### **A Dispersion Modeling Analysis of Downwash from Mirant's Potomac River Power Plant**

**Mirant Potomac River, LLC  
Alexandria, VA**

**ENSR Corporation**  
**August, 2005**  
Document Number 10350-002-410

**Comments on the Protocol, Revised March 24, 2005,  
For Mirant's Potomac River Generating Station Air Impacts Modeling**  
By John McKie, April 25, 2005 (Revised May 5, 2005)

Figure 3-6 Sectors Indicating Land Use at the Mirant Site

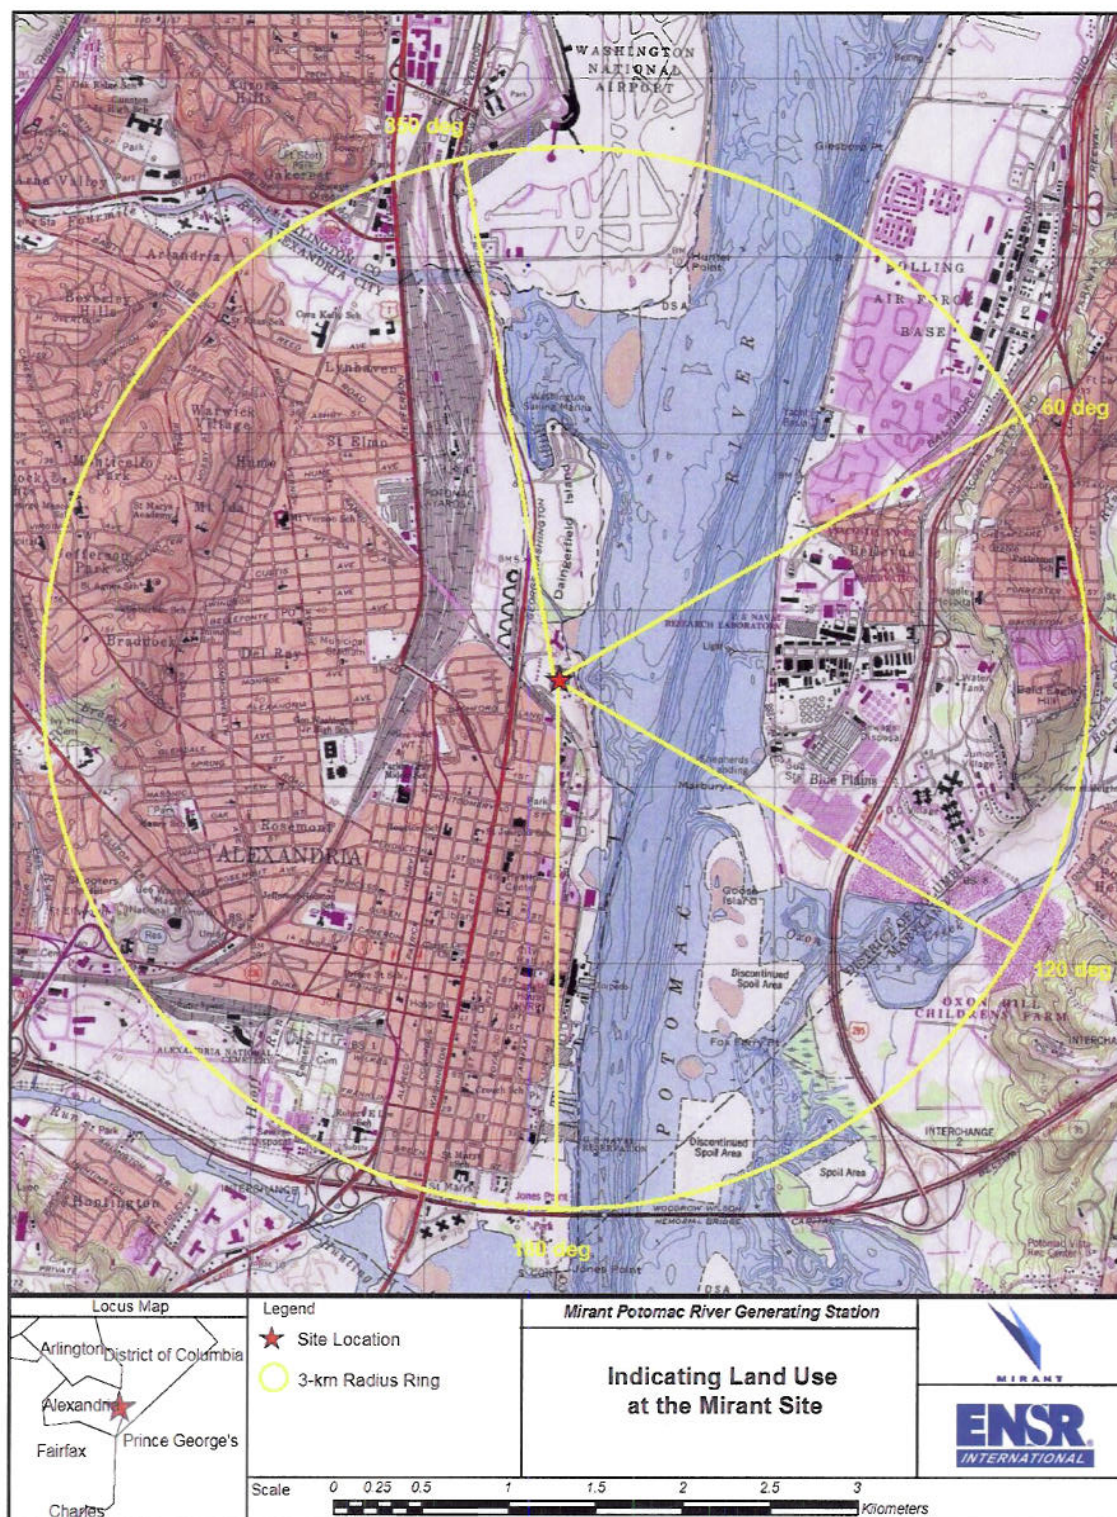
As agreed to, change the 350 degree radial to 360 degrees in sector 3 of the land use map to ensure the envelopment of the Marina Towers building as per the outside commenter. Additionally, add the flagpole receptors to the north of the Marina Towers building as also described by the outside commenter. These comments were also endorsed by the other significant commenter. In addition, review the land use characteristics with respect to changing two sector sizes and addressing the land use comments.
